Reply to: 2430 Commercial Timber Sales

Subject: Hunter's Lake Timber Sale, proposed

Subject: Comments on Ross Frid's Hunter Lake Sale  
(Reference 7/29/82 memo)

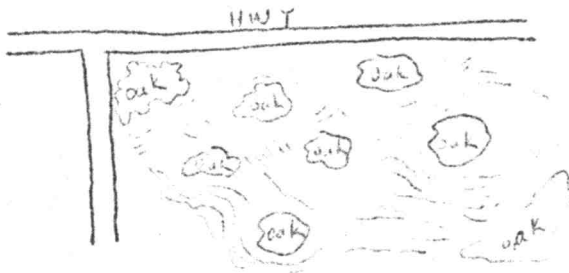
b) The center portion should be left as originally proposed (clearcut), but I'd like to see it treated for slash. If burning is a must, try to not burn the oak portions. I suggested to Lee that perhaps the oak portions could be roller chopped. This would only be in areas where oak is not too thick. Perhaps a scheme as shown below would work.
